Reply Comments to C802.16m-08/073

Document Number: 80216m-08/115r1

Reply comments to contribution C802.16m-08/073 and MMIB performance evaluation

Inaccuracies in MMIB (2)

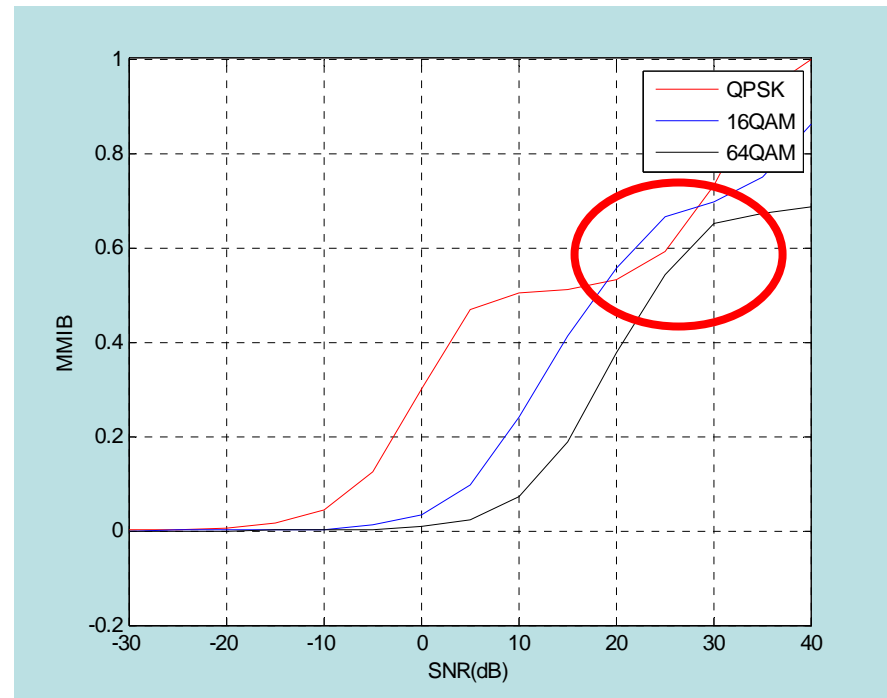
Consider the following example for the channel matrix, H

It can be seen that MMIB does not satisfy the basic property that the bit-level information metric should decrease with increasing modulation level.

16QAM MMIB vs. RBIR SNR=10dB

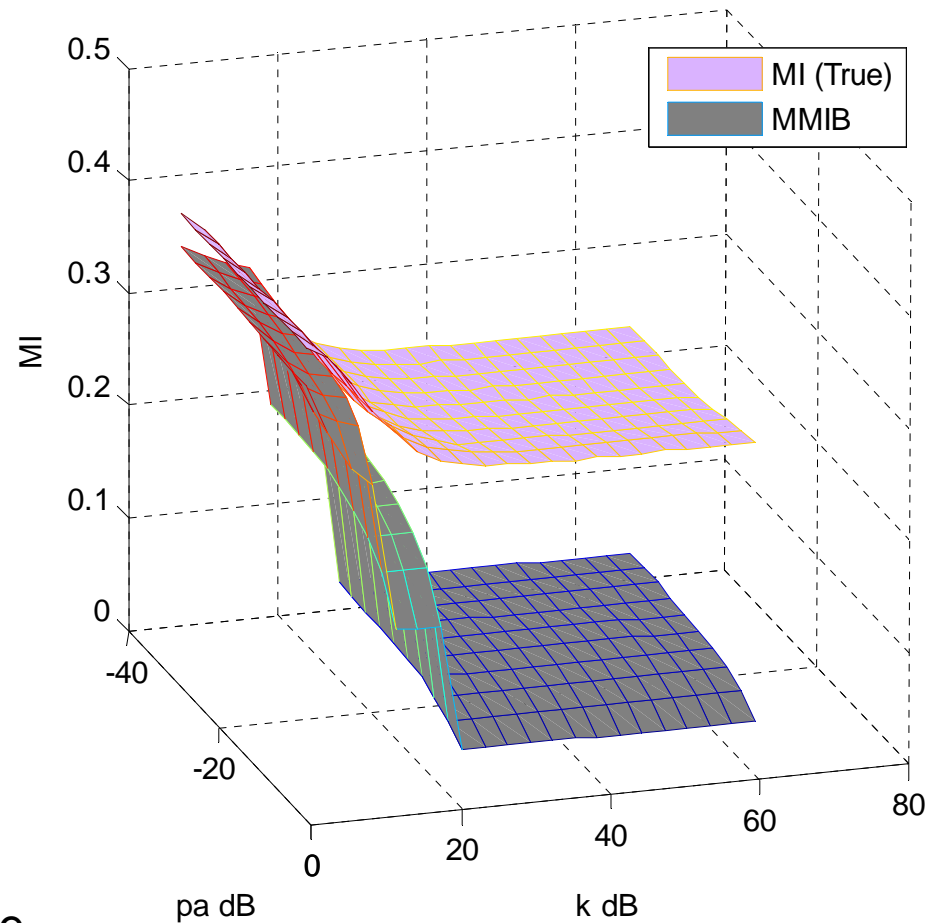
- MMIB PHY abstraction is inaccurate
- Different offsets may be needed for different k/pa and MCS levels

Inaccuracies in MMIB (4)

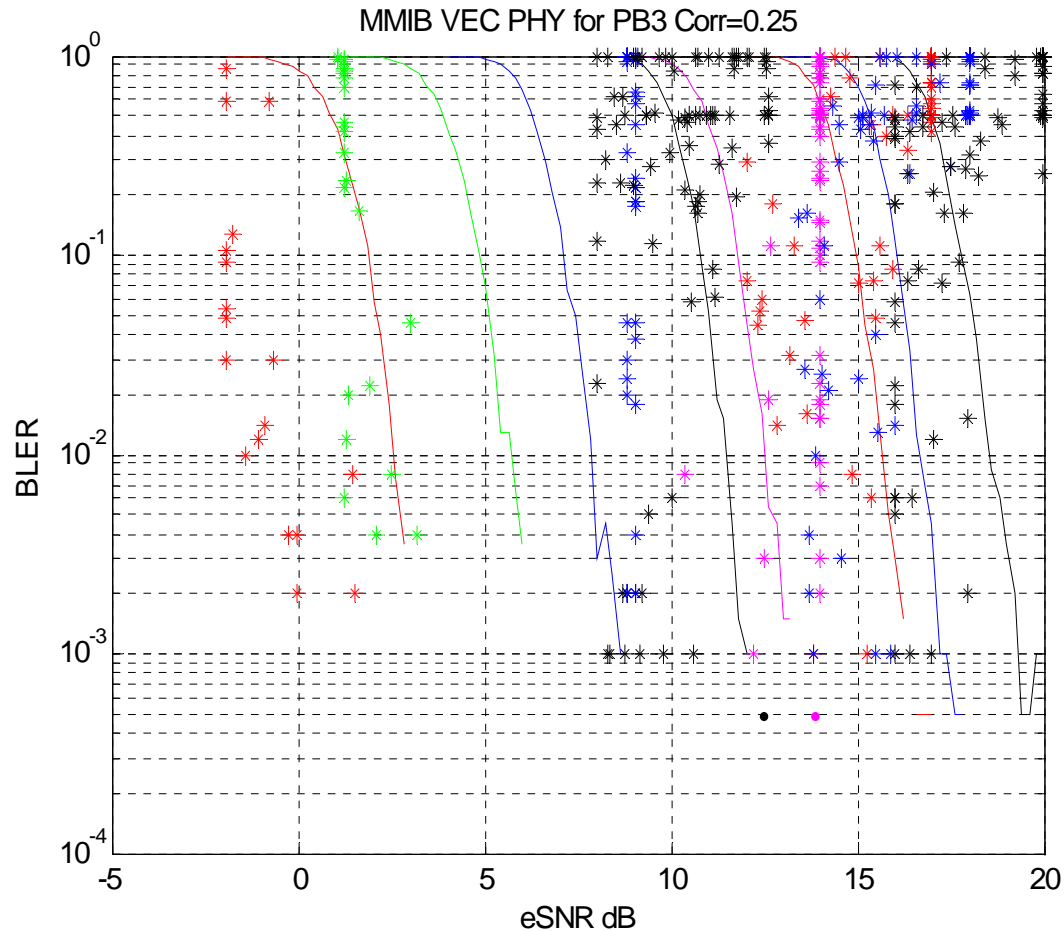
- MMIB PHY abstraction is inaccurate, especially for higher MCS levels
- Each MCS may need different offset
